**SAN ONOFRE NUCLEAR GENERATING STATION
UNIT 1**

**MASONRY WALL EVALUATION
RESPONSE TO NRC REVIEW**

APPENDIX A : TECHNICAL QUESTIONS

**COMPUTECH ENGINEERING SERVICES, INC.
Berkeley, California**

FIGURE 3.4 STRAIN DISTRIBUTION IN FACE SHELL

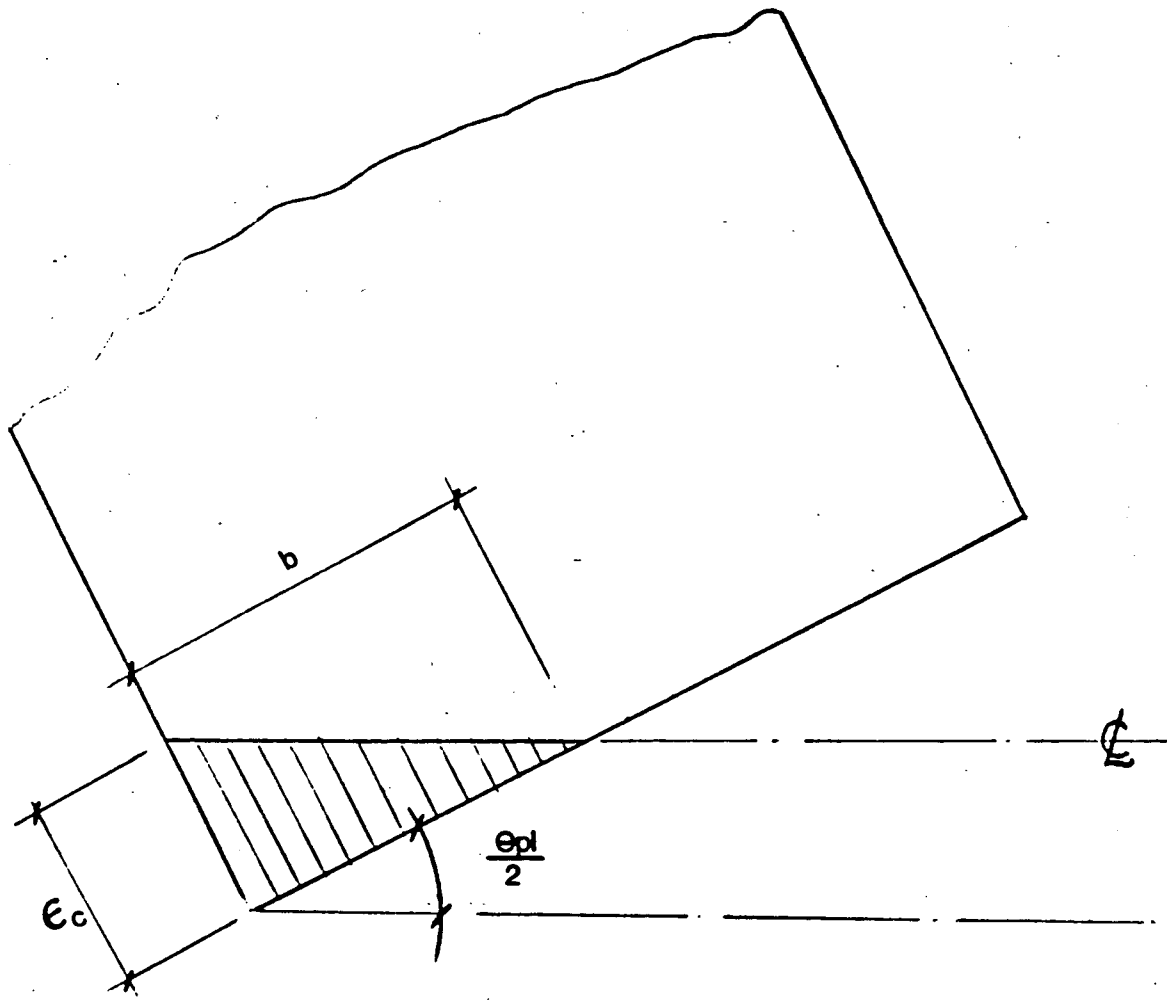
"During the entire analysis, the masonry face shell is assumed to remain elastic. There is a likelihood that the compressive stress at the face shell may exceed the f'_m value and spalling of the face may occur. There is no grout core to stabilize this situation. This aspect needs thorough investigation in terms of the strength of the masonry, strain/stress magnitudes at face shell, and actual masonry block behavior during shaking."

Consider the area of face shell in contact, as shown in Figure 3.4. There are 2 unknowns:

$$\begin{aligned}\epsilon_c &= \text{maximum outer fiber strain} \\ b &= \text{contact length}\end{aligned}$$

From assumption 4 in the previous section, the curvature may be obtained from the plastic rotation and plastic hinge length as:

$$\epsilon_c = \theta u / L_p, \text{ assumed uniform.}$$

also the curvature may be expressed as:

$$\psi_c = \epsilon_c / b$$

therefore

$$\theta u / L_p = \epsilon_c / b$$

$$\epsilon_c = b \theta u / L_p \dots \dots \dots (3-1)$$

FIGURE 5.3 : INCREASE IN STEEL STRESS AFTER YIELD

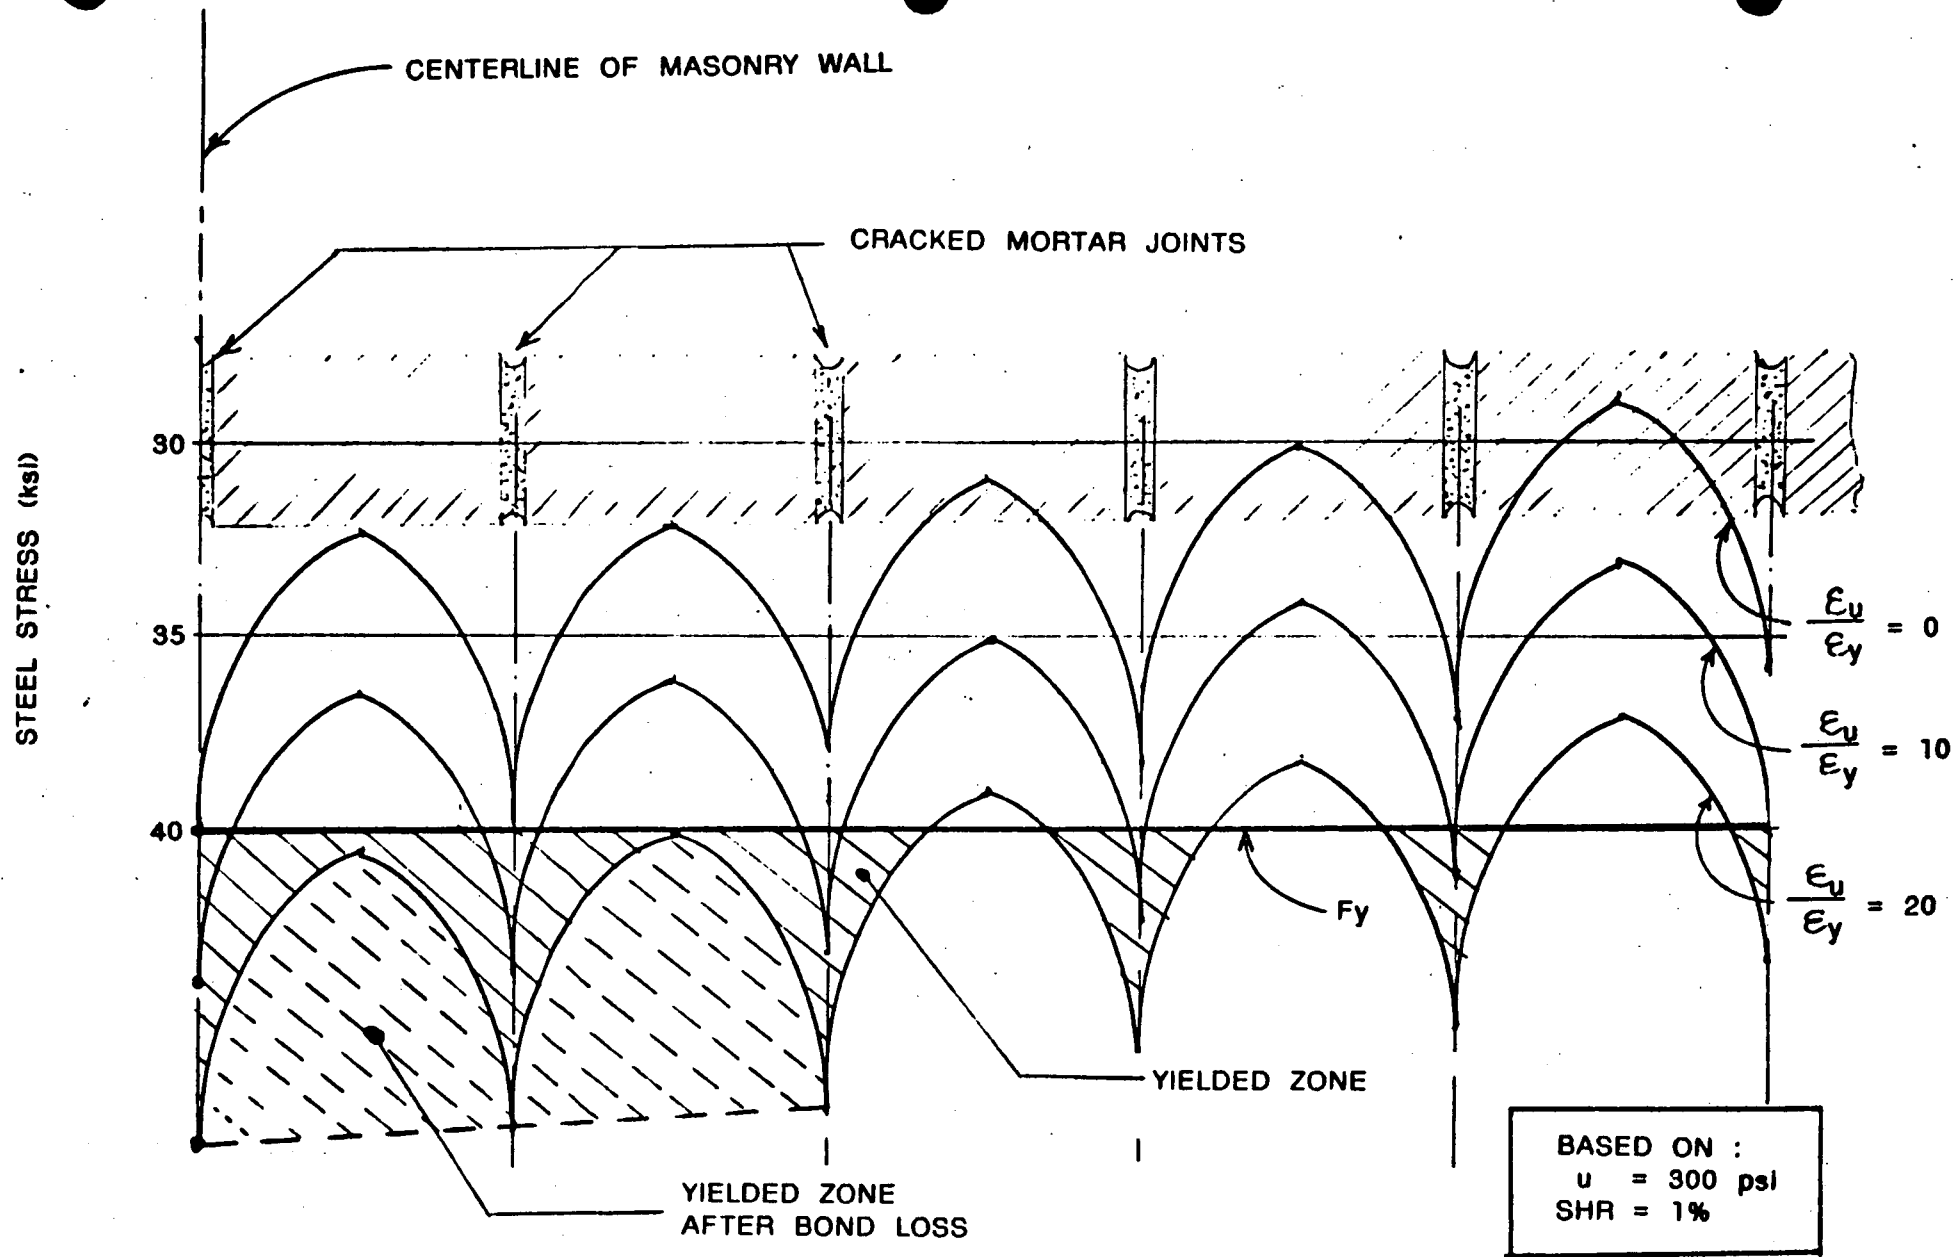
"The selection of the length of rebar assumed to yield in the analysis is arbitrary. At present, there is no data to provide the basis for such selection. Also, it needs to be verified that the parameter, L_{jt} , related to cracked joint widths is problem independent."

Consider a section of wall adjacent to the centerline as shown in Figure 5.3. For an increasing uniform load the maximum moment occurs at the center and the steel stress will first reach a value of yield at this position. At adjacent mortar joints the steel stress is defined by the shape of the bending moment diagram. Between the mortar joints the steel stress reduces to some lesser value depending on the stress transferred to the masonry unit by bond.

If the value of the bond stress, u , and the steel strain hardening ratio, SHR, are known the points at which yielding will spread may be computed. Figure 5.3 has been computed for values of $u = 300$ psi and $SHR = 1.0\%$. The successive lines drawn are for strain ratios (ϵ_u/ϵ_y) in the steel of 0, 10 and 20 times yield respectively. It can be seen that at a ratio of 10, yielding has spread to three adjacent blocks but the steel stress within the blocks remains below yield. At a ratio of 20, yield has been exceeded throughout the 2 blocks adjacent to the

The value used in the San Onofre, Unit 1 wall evaluation was 9" each side of centerline, for a total of 18". The values computed above show that this situation would occur under relatively modest strain ratios between 10 and 20, or less than this for lower bond stress and/or higher strain hardening. In fact the bond stress would likely be considerably lower due to the effects of cyclic loads.

FIGURE 9.1 : COMBINED LOAD ON WALL TB-9

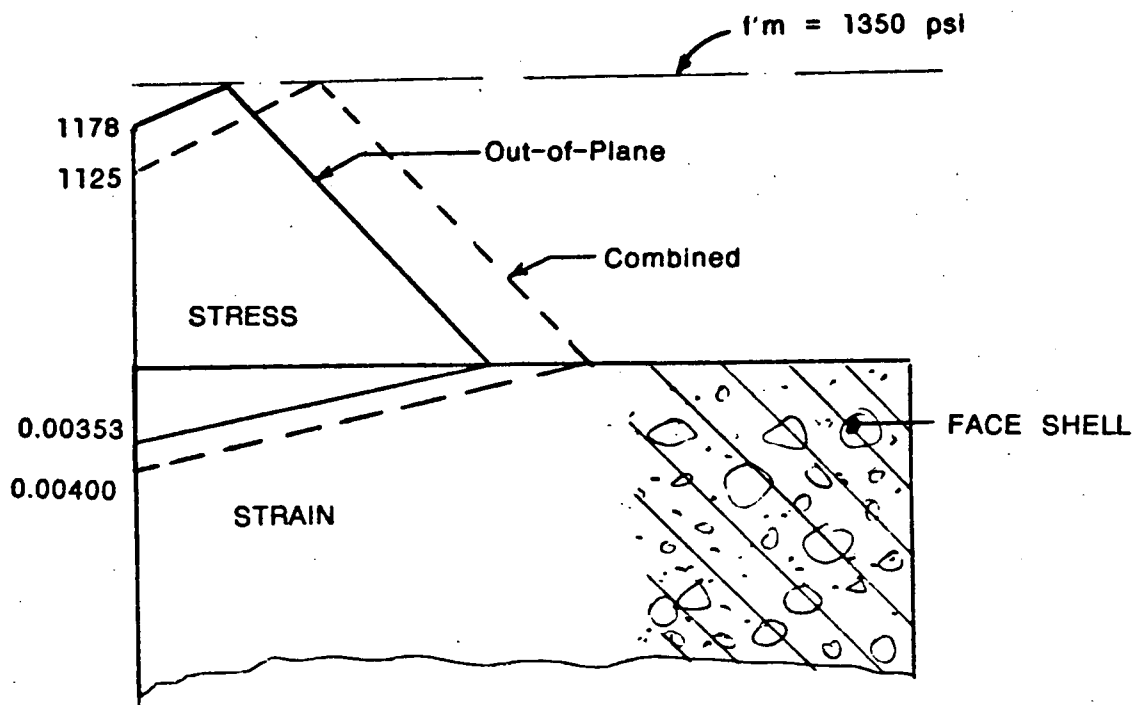
"Assessment of the impact of transverse load on in-plane carrying capacities, and vice versa, is needed."

Wall TB-9 is subjected to the greatest face shell strain, as shown in Table 3.1. The stress and strain distributions under 100% out-of-plane loading are as shown in Figure 9.1.

As simultaneous in-plane loadings are applied the strain will increase parallel to the out-of-plane strain until the spalling limit strain of 0.0040 is reached, as shown in Figure 9.1. Therefore the maximum allowable in-plane loads are such as to cause an increase in strain from 0.00353 to 0.00400. The maximum compression per unit length of face shell may then be computed as the difference between the areas of the two stress distributions.

From the stresses in Figure 9.1 this incremental compression has been computed as 64 lb/inch. As the wall is effectively rigid in-plane and subjected to a uniform acceleration the loading is a uniformly distributed load up the wall height. Therefore a relationship between the acceleration level, a , and the maximum extreme fiber compression, f_c , may be derived as shown in Figure 9.3.
